GRADING AND EROSION CONTROL PLAN

2217 JANITELL ROAD

COVER SHEET

PCD File No. PPR2629

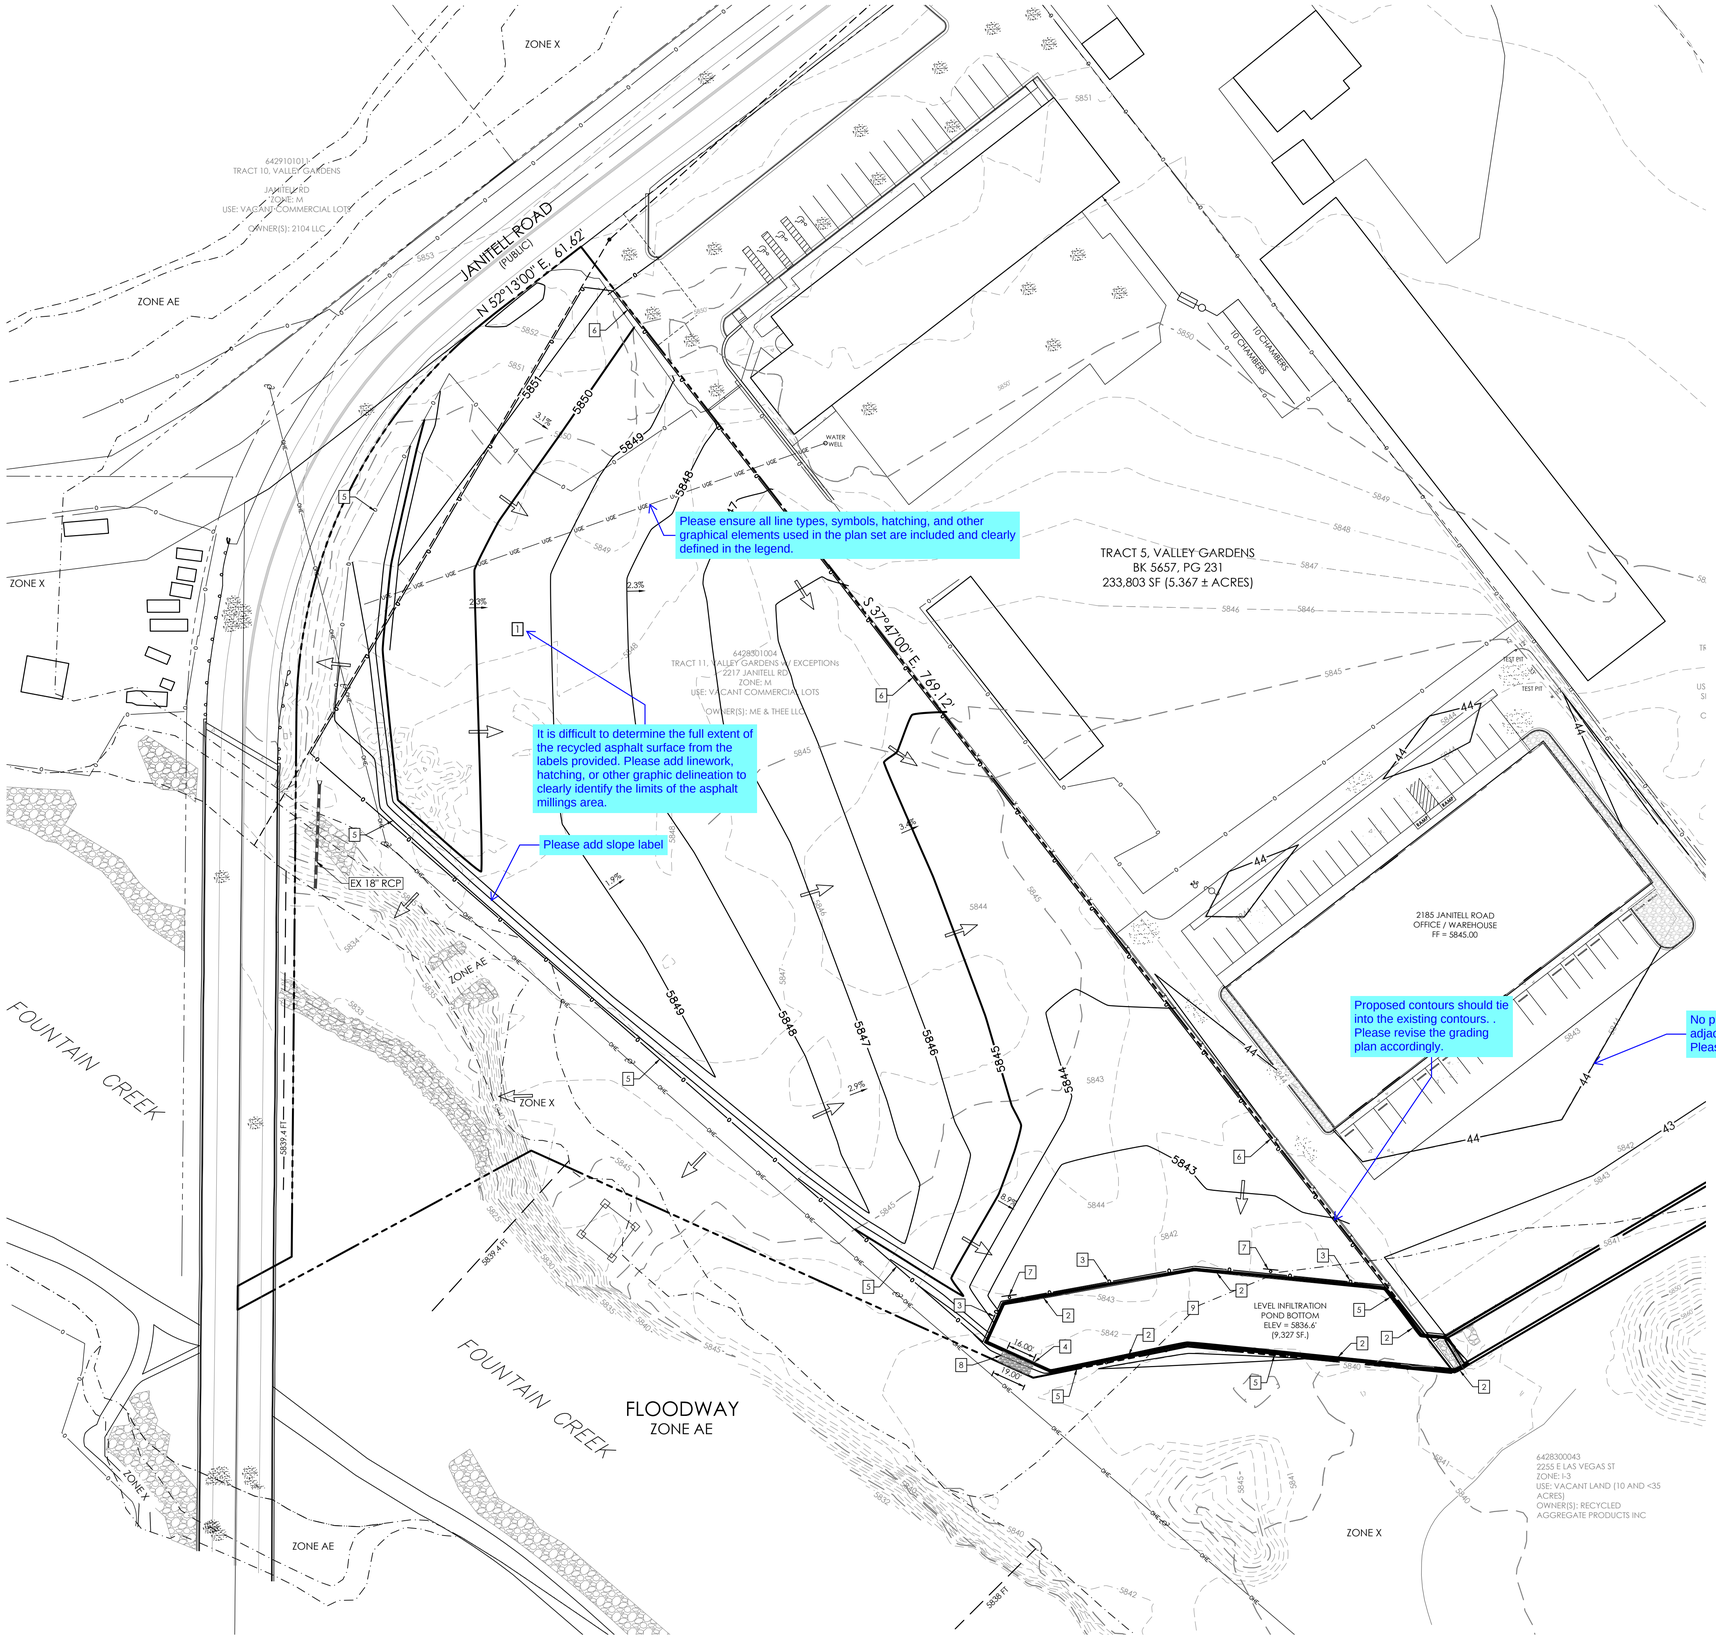
The signing and striping notes shown are not the current El Paso County standard notes. As no signing or striping improvements are proposed, these notes may be removed from the plans.

Add lines for signature/stamp and date

EROSION DETAILS

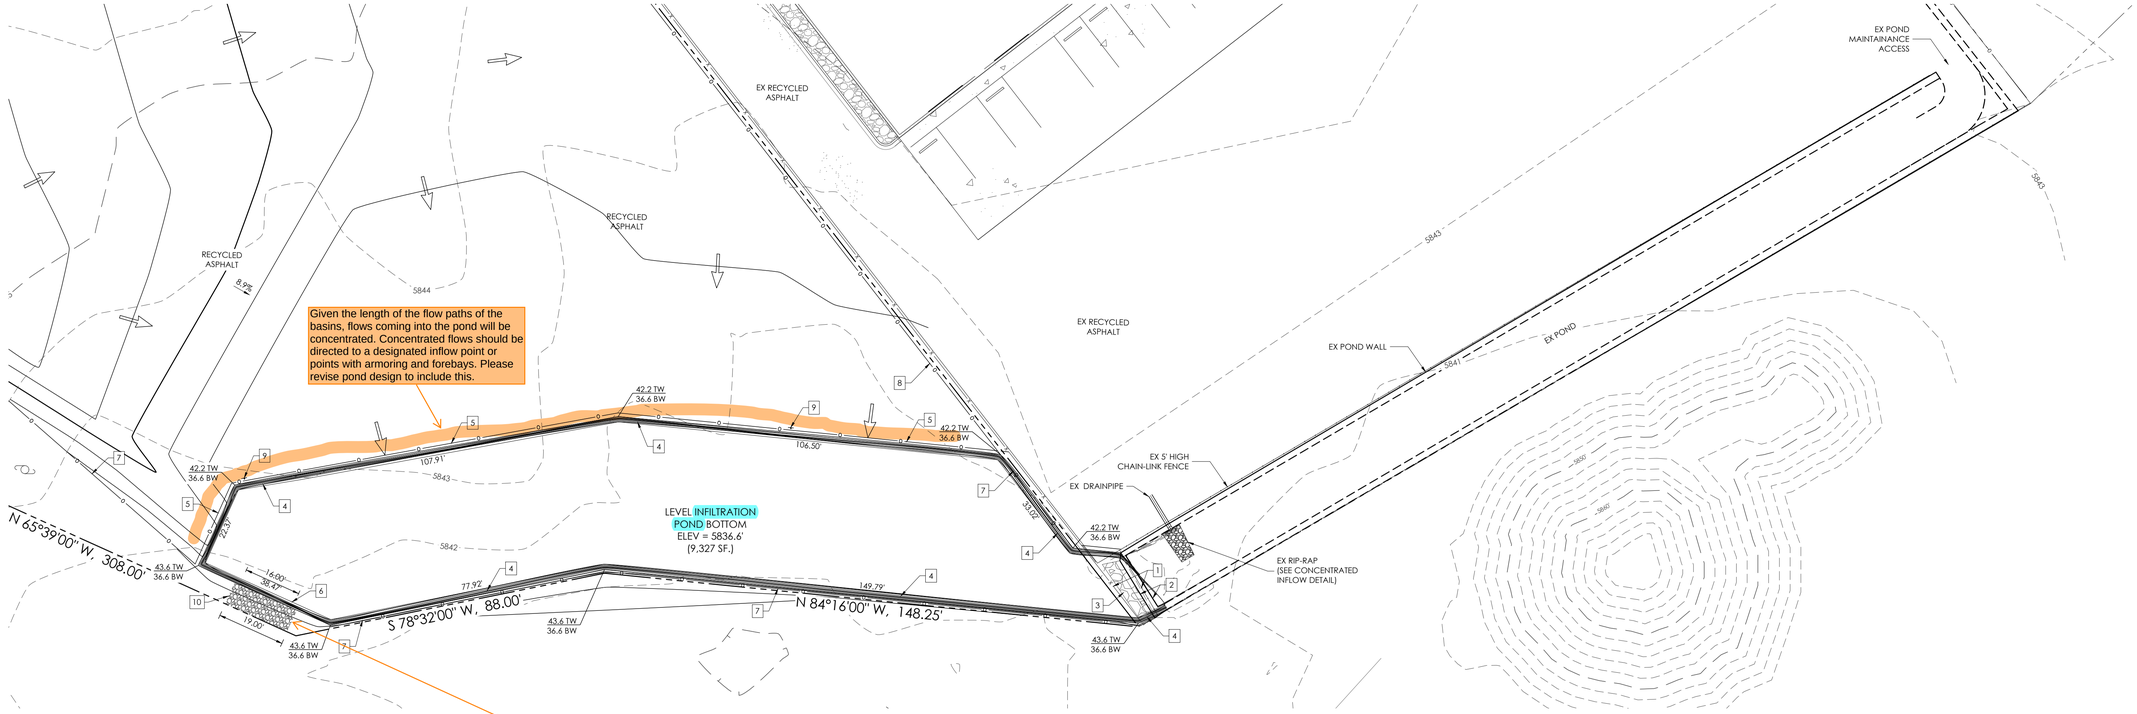
Provide construction control measure details for the following:
- Sediment control log
- TSB (if standard detail is applicable)
- Inlet/outlet Protection
- Seeding & Mulching

Also specify a seed mix. MHFD TS/PS detail does not include a permanent seed mix. Need to specify a seed mix & application rate specific to those species appropriate for this project location. See COS SCM Table 5-1 and 5-2 for recommended mixes for the area.
